TECHNICAL MEMORANDUM

To: American University Campus Plan Team

Date: May 19, 2011

Subject: Addendum to Transportation Report – American University 2011 Campus Plan

Figure 15: Total Future Traffic Controls, Lane Designations, and PM Traffic Volumes with Proposed Signal

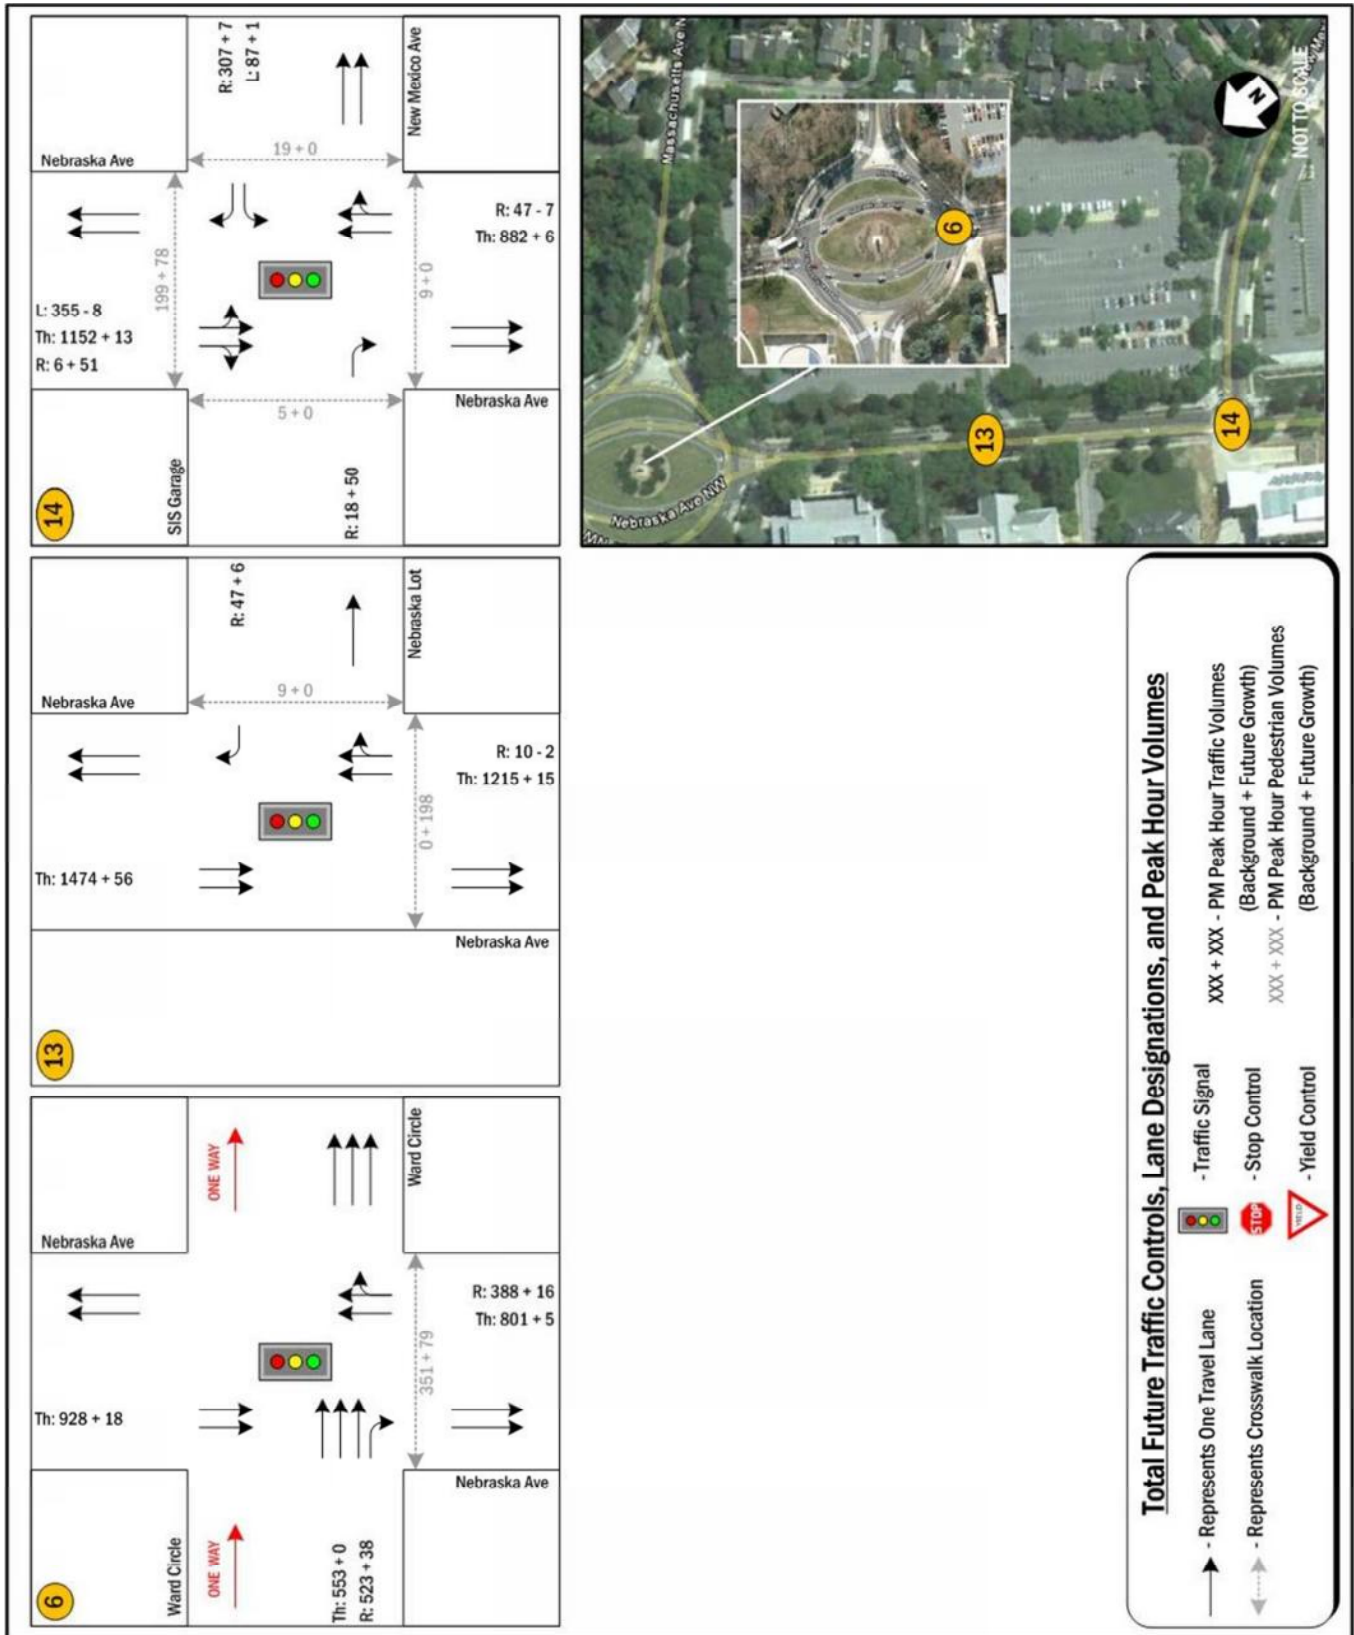
development on the East Campus. This traffic signal would allow for vehicles to exit the East Campus, as well as allow pedestrians to cross at a signalized location, moving pedestrians away from the adjacent signalized crossings. Trip distribution for the pedestrian trips added by the East Campus was based on an approximate 50%/35%/15% split of pedestrians between the New Mexico Avenue, RIRO driveway, and Ward Circle crossings along Nebraska Avenue, respectively, due to the layout of the site. The future pedestrian volumes added to the crosswalks affected by the 2011 Plan are shown in Table 4. The future pedestrian volumes for the affected crosswalks are shown on Figure 14 and Figure 15 for the morning and afternoon peak hours, respectively.

Figure 20: Total Future Lane Configurations and Capacity Analysis Results with Proposed Signal

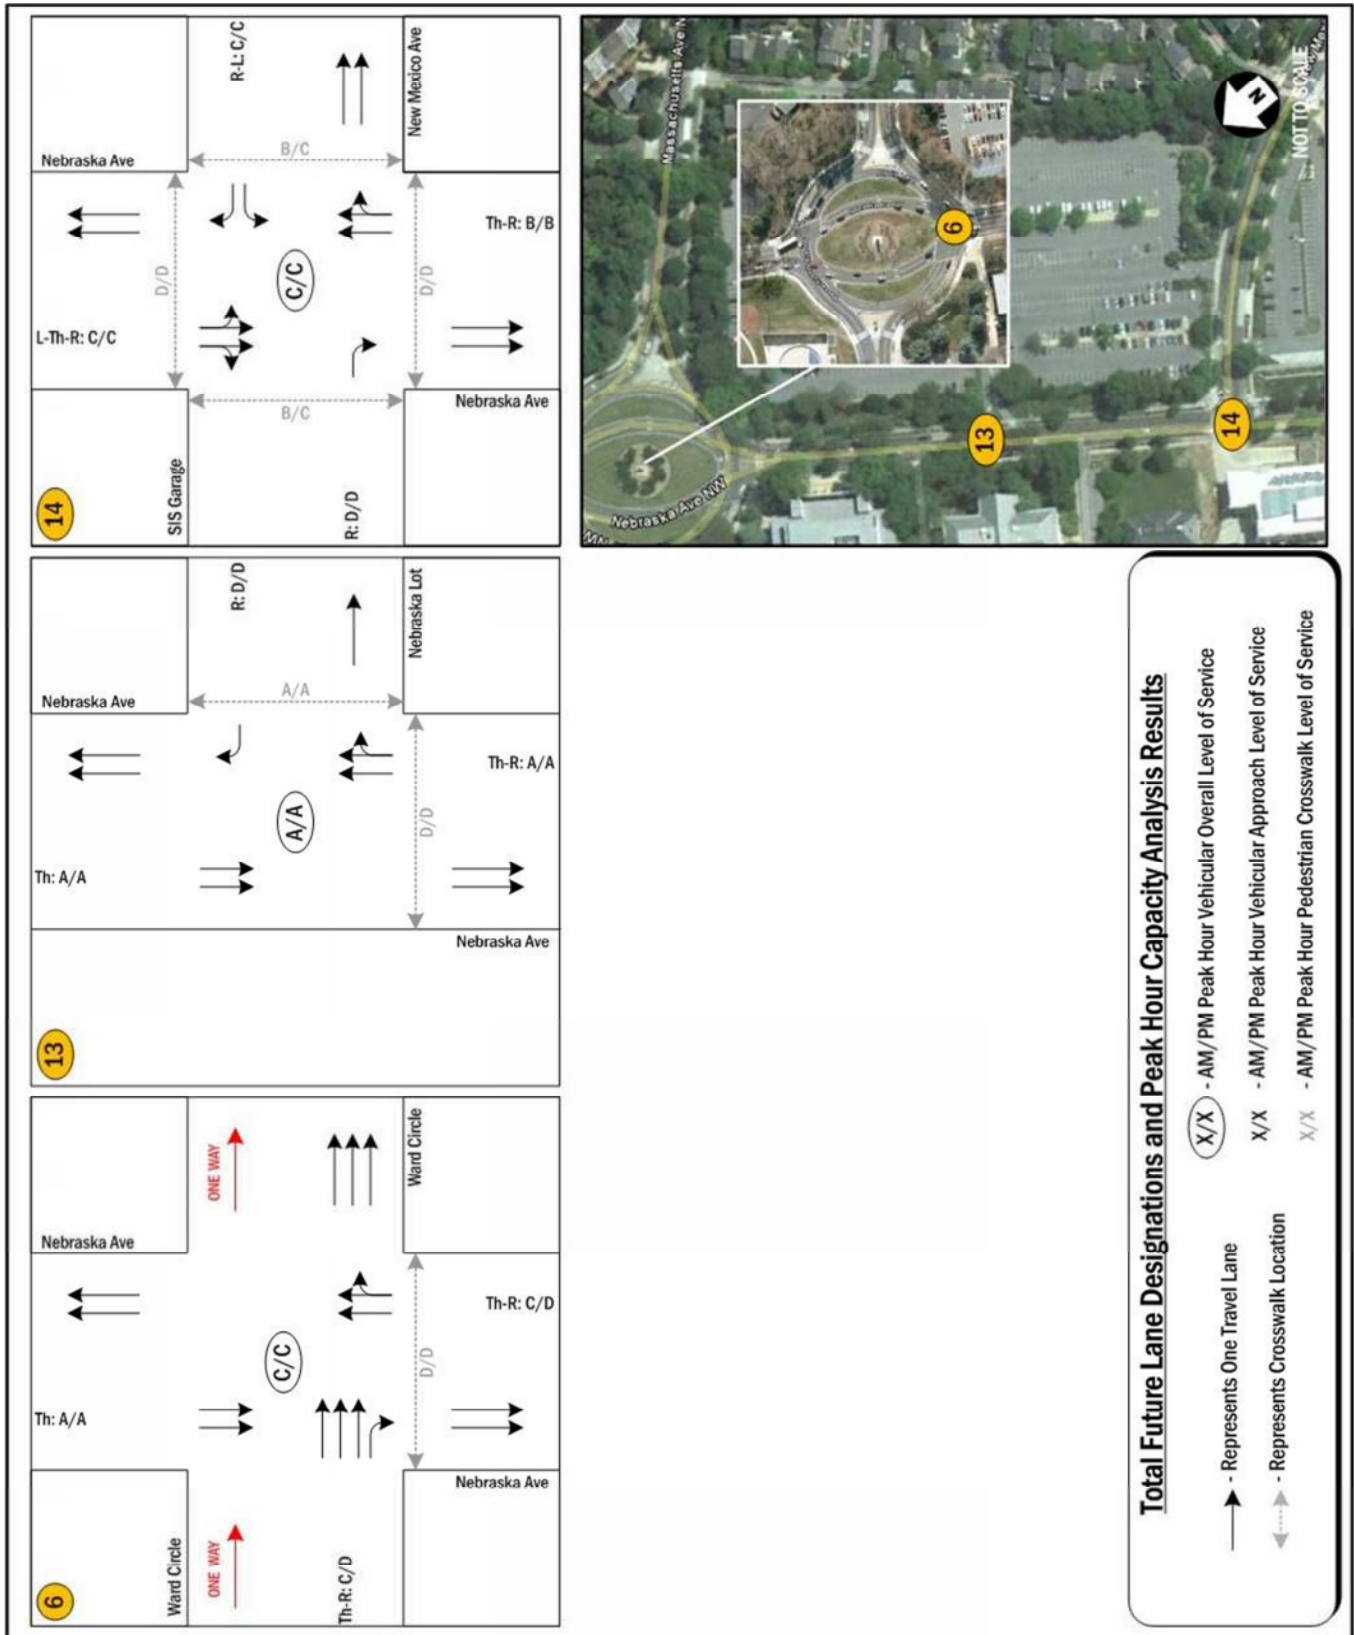
Table 6 and Table 7 show the results of the capacity analyses, including LOS and average delay (in seconds). The results of the capacity analysis with the proposed signal are shown shaded in grey and include the RIRO signal, as well as the two adjacent signals along Nebraska Avenue. The capacity analysis results are also shown on Figure 16, Figure 17, Figure 18, and Figure 19. The capacity analysis results with the proposed signal are shown on Figure 20.
